BDR SONATA EAST

EARLY DESIGN GUIDANCE SECOND MEETING

DPD# 3017382
NOVEMBER 25, 2014

OPTION 3 (PREFERRED)

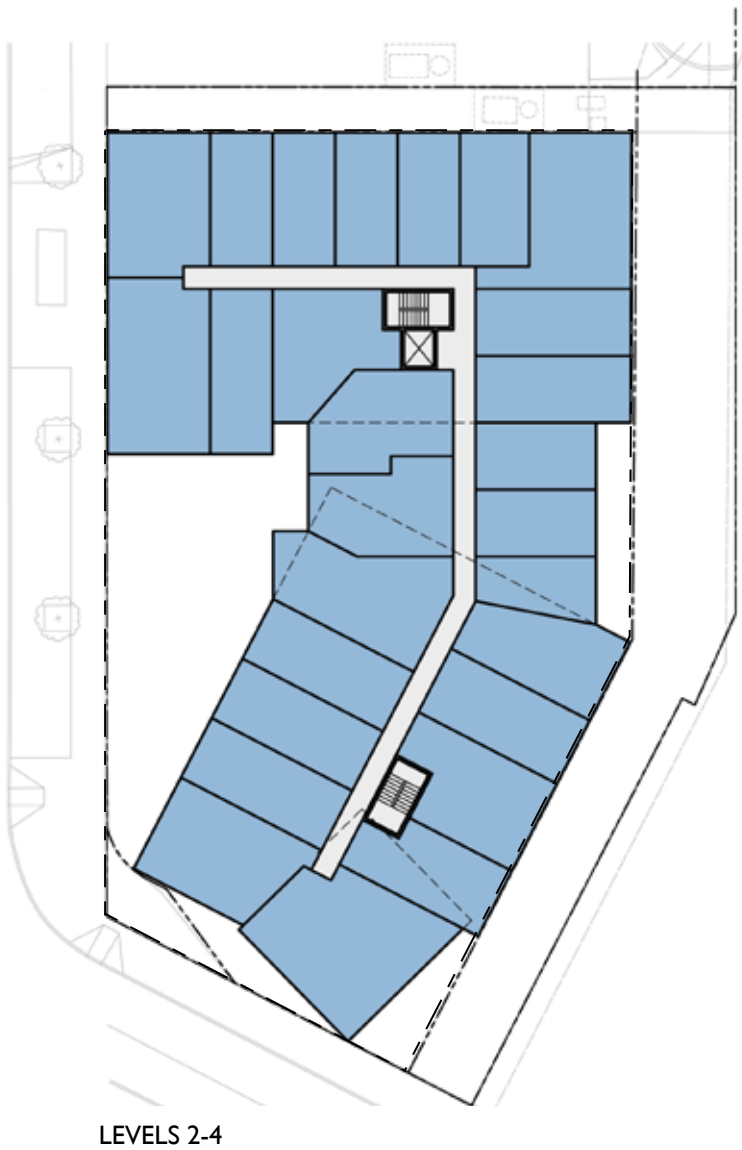
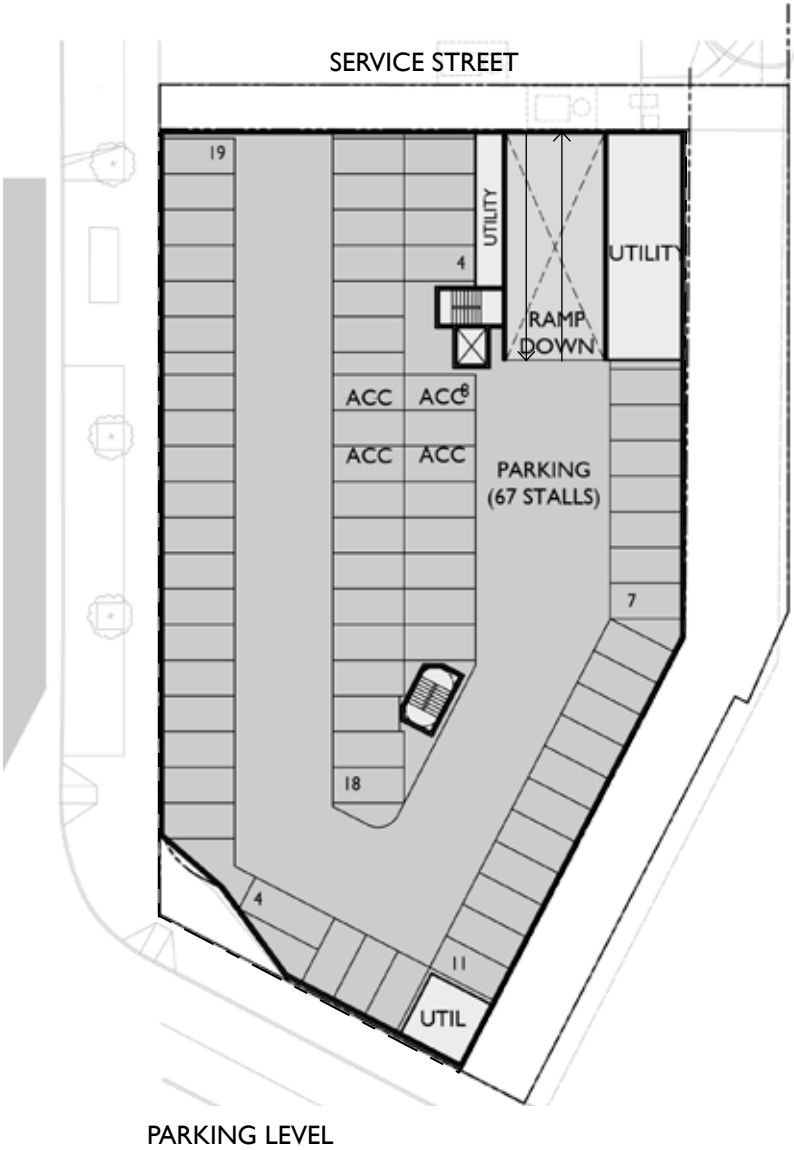
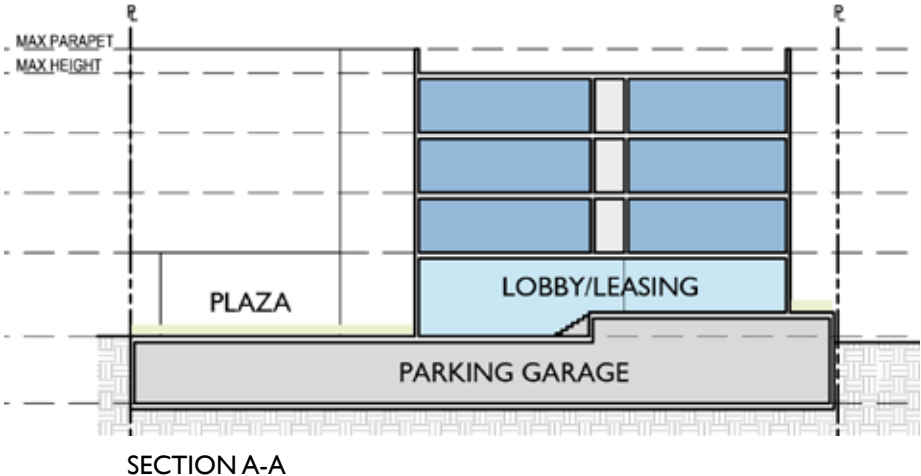
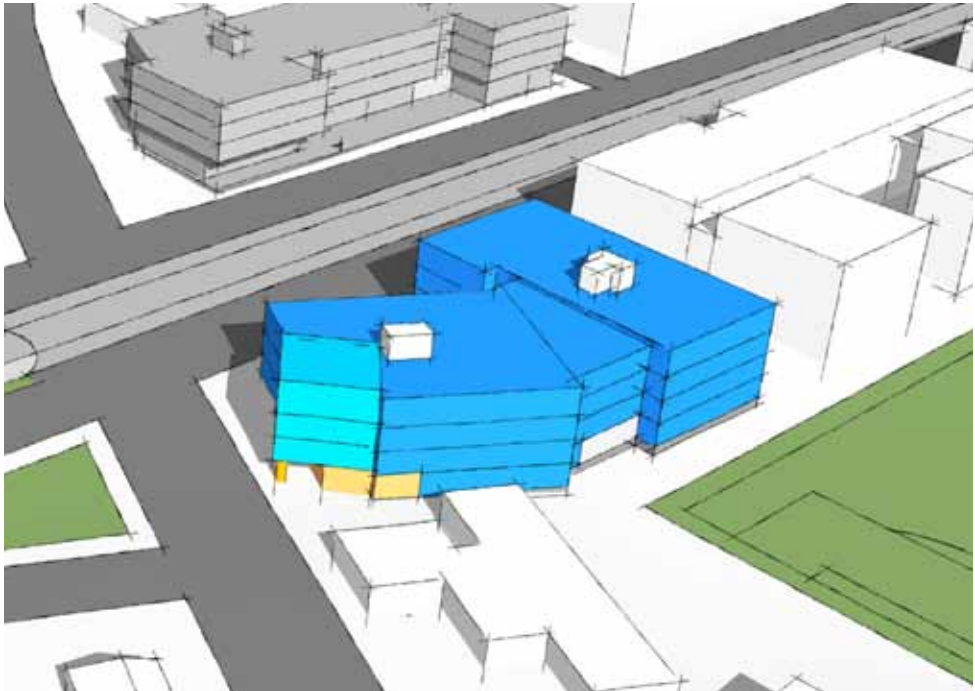
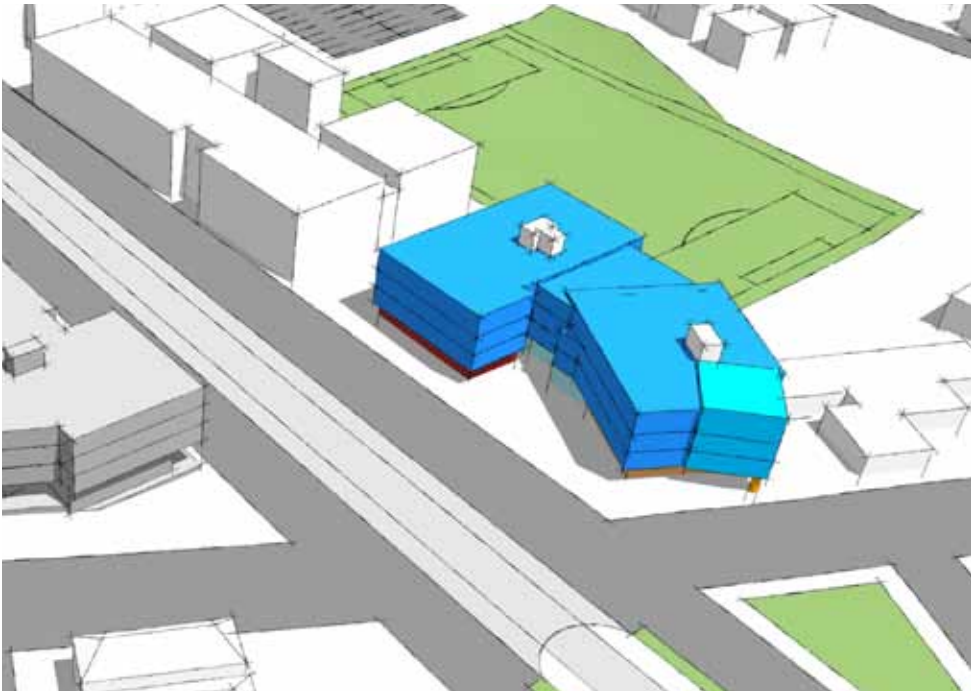
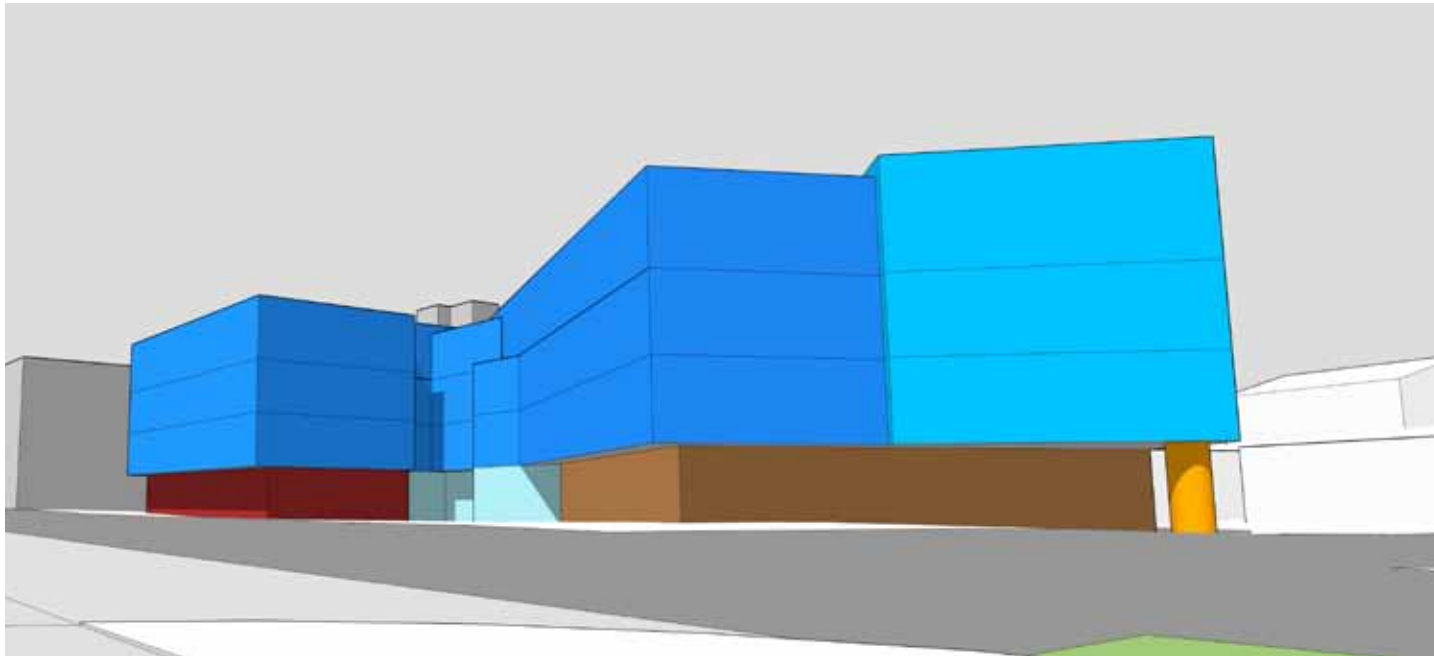
The building’s prevailing geometry is unconvincing. The depth of the plaza along MLK and its adjacent residential (including live/work units) uses would act to inhibit a lively pedestrian open space. The building’s geometry on the south side appears awkward in its relationship to the corner. The intersection has an important has an important function as a gateway. The proposal does not seem to acknowledge it.

The Board found the massing of the east building’s southern volume the most troublesome and requested two new alternatives that better address the gateway and the light rail station. The mass blocks light into the plaza facing MLK Way and constricts the pathway along the east edge of the site from merging well with the plazas on the south and west sides. For the new massing studies, the Board requests better view studies from the south.

East Building. The choices of uses and their size facing the plaza do not serve to activate the plaza on MLK Way. The residential lobby and amenity consume too much valuable real estate on the plaza’s perimeter. The live/work units, particularly the southern-most, ought to be retail space to attract more pedestrian activity. The shops that line Tamarack Place and other buildings north along MLK create a strong pedestrian corridor. Placing retail rather than live/work between Tamarack Pl and the plaza would augment and extend a pleasant storefront district.

East Building: The Board noted the awkward geometries of the proposals. In part this may reflect the architect's difficulty in responding to the irregular shaped site. Redesign the massing to frame a shallower open space along MLK Way and to acknowledge the importance of the intersection. In general, Option #2 with several refinements is a more workable solution than the others.

East Building. The Board preferred a shallower plaza on MLK as illustrated by Option #2. The east facing notch or façade modulation as shown in the same option received support.

During the first EDG meeting, the board was concerned with the southern end of the building and its relationship to the street intersection and the plaza. The relationship of the ground level uses and the massing of the building above has been modified in response to this comment. The live/work unit that faces into the plaza has been lengthened in order to provide a large work area at the corner; all four live/work units will have removable unit demising walls so that they can transition to retail spaces as the demand for retail develops. The retail uses at the southern end of the building are large with good visibility. The retail uses have been extended north into the plaza space along with the coffee shop that faces into the plaza. The depth of the plaza has been reduced where the Flex Space (*coffee shop*) occurs in order to increase connectivity and visibility of the space. The Flex Space is intended to be a use that would appear as retail but also function as a resident amenity. The residential lobby entry is still in the northeast corner of the plaza and is slightly recessed giving the lobby entry a more private residential relationship to the plaza and the pedestrian sidewalk realm.

Two alternate massing solutions are included in the revised EDG book. Both include a tower element at the southern end of the project. The new preferred option includes a tower element that has been rotated in order to open the building up at the ground level for pedestrian and visual connectivity to the play field. This new tower element provides strong visual statement at the intersection and at this prominent gateway site. The mass of the building above and at the plaza has been pulled back to allow better sunlight into the plaza and the retail in the plaza has been pulled back to align excellent visual connection from the pedestrian curb ramp to the south.

The design of the residential lobby has evolved into more of a ‘Great Room’ that visually extends from the plaza entry through the building to the east façade with a raised area that overlooks the play field. By rotating the lobby and associated amenity space, we have greatly reduced the impact of the residential lobby on the plaza. This in turn, has increased the amount of retail in the plaza and has introduced a ‘*coffee shop*’ that projects out into the plaza on the preferred scheme. This increased retail space and especially the ‘*coffee shop*’ should help to activate the plaza. Note that the north end of the plaza is quieter and more residential in nature; this is caused by recessing the residential lobby and locating it in the northeast corner. In response to this more quiet residential part of the plaza, the live-work units are proposed

The southeast corner of the building includes an angle to the plan that provides good visual connection to the pedestrian walkway and the adjacent play field. In plan, this angle appears to be dissonant, but three-dimensionally we have used this angle to create a rotated tower element that unifies the overall design of the building at this prominent corner. This new proposed tower element does not continue down to the ground level providing either a nice covered outdoor seating area for the related retail space, a comfortable plaza area at the southern end of the building, or simply additional pedestrian connection to the east. This new tower element has been rotated in order to open the building up at the ground level for pedestrian and visual connectivity to the play field. This new tower element provides strong visual statement at the intersection and at this prominent gateway site. In general, the massing of the building has been modified to include a variety of parapet heights that creates hierarchy between the southern tower element, the larger rectangular masses, and the lower knuckle of the building providing a more visual building massing.

The west facing retail façade has been pulled back to allow visual alignment between the plaza and the pedestrian curb ramp at S Alaska St. In the new preferred scheme, the '*coffee shop*' has been pulled out into the plaza thus reducing the size of the plaza and increasing the visibility into the coffee shop. The residential lobby entry has been recessed at the back of the plaza to help create a more subdued semi-private entry to the building.

SHADOW STUDIES - OPTION 3 - PREFERRED

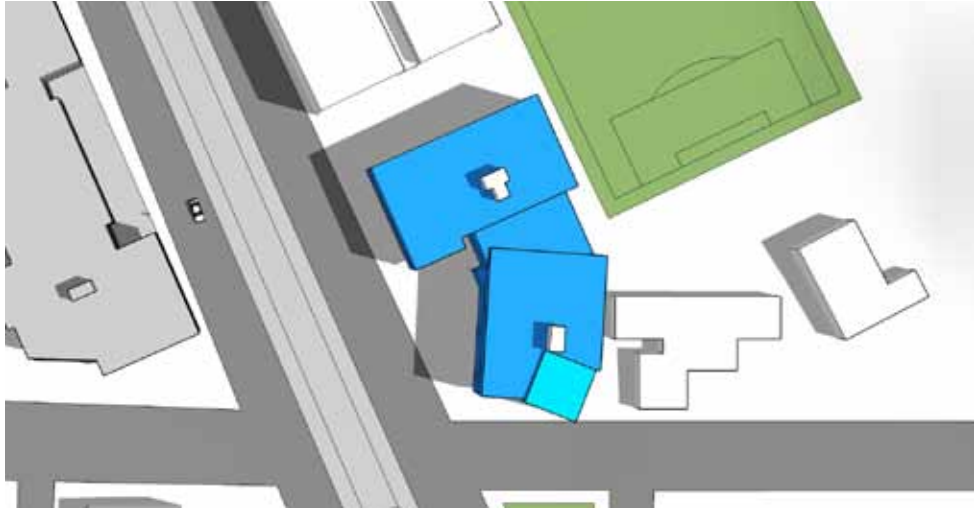
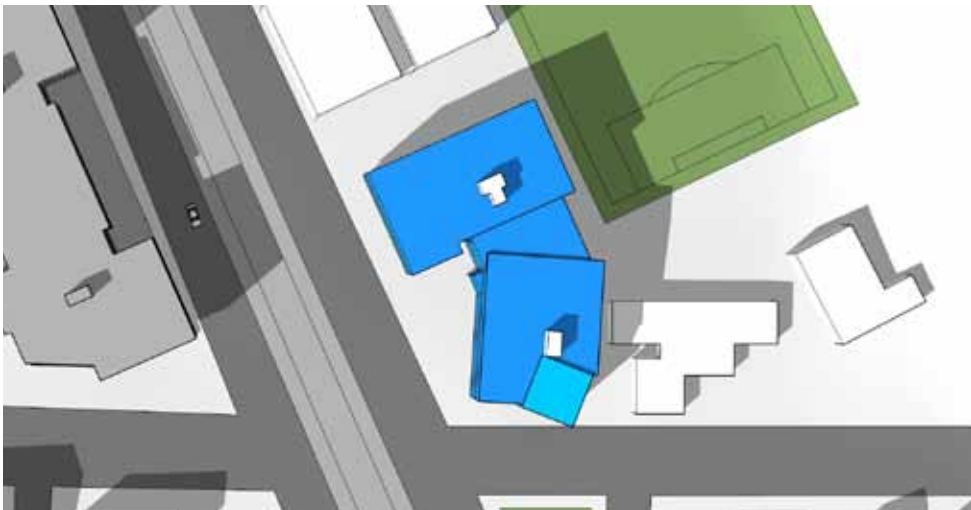
The impact of shadows and sunlight on the plazas should be analyzed to ensure that these significant open spaces on both the east and west building are comfortable and habitable.

The plaza fortunately faces south and west which will take advantage of good solar exposure late in the morning and especially in the afternoon. The building across the street to the west is roughly 150’ away and will not cast shadows into the plaza.
